## 三相モータの生産拠点変更および新規仕込生産化のお知らせ

当該モータの生産拠点を MITSUBISHI ELECTRIC AUTOMATION (THAILAND) CO., LTD に変更します。  
拠点変更に伴い、本体、銘板、梱包箱の仕様を変更します。主な変更点を次頁以降に示します。  
なお、従来モータから機能・特性に変更はありません。

発行 日付	2015年 2月	件 名	三相モータの生産拠点変更のお知らせ	三菱電機株式会社名古屋製作所 〒461-8670 名古屋市東区矢田南5-1-14 Tel (052) 721-2111大代表
----------	----------	--------	-------------------	--

(1) 本体

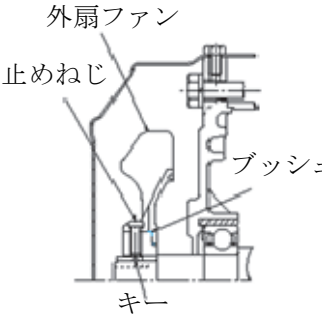
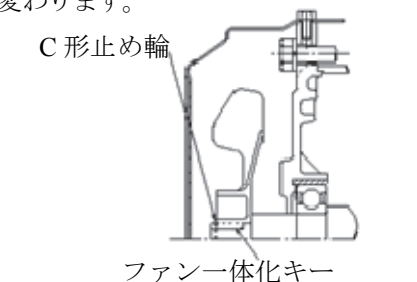
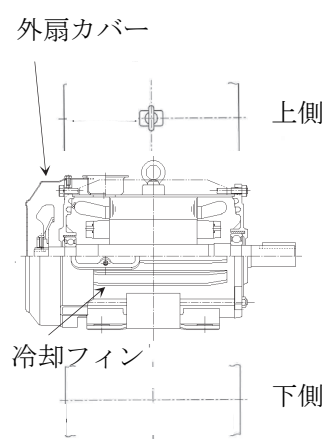
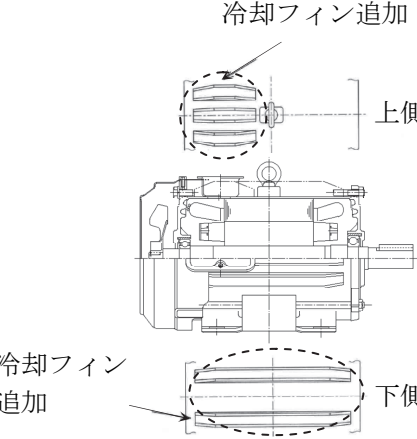
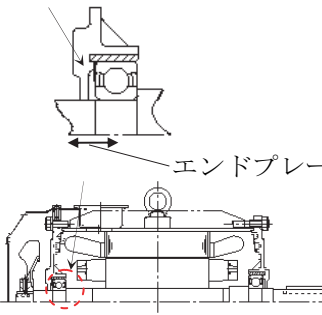
対象	項目	変更前	変更後	備考
100L 機種 (No.6,12,18)	外扇 ファン		<p>外扇ファンの形状、およびブッシュ・キー方式からファン・キー一体構造に変わります。</p> 	<p>部品手配時は製造番号も併せてご連絡ください。 (従来外扇ファンとの取付互換性はありません)</p>
100L 機種 (No.6,12,18)	外扇 カバー 冷却 フィン		<p>外扇カバーの形状および冷却フィンの枚数が変わります。</p> 	
SF-PR 及び SF-PRO の 100L 機種 (No.6,18)	エンド プレー	<p>調整座金位置</p> 	<p>SF-PR、SF-PRO で軸を共用化するため軸寸法が変わり、エンドプレーが小さくなります。 SF-PRO はエンドプレー調整座金が無くなります</p> 	<p>エンドプレーとは軸の水平方向の遊び量を示します。 軸寸法は内部のみ変更となり、外形寸法の変更はありません。</p>
SF-PRO の 80M,90L 機 種 (No.13,14, 15,16,17)	端カバ ー		<p>端カバーの内径及び厚みが変わります。</p>	<p>従来端カバーと取付互換性があり、保護性能も変わりません。</p>
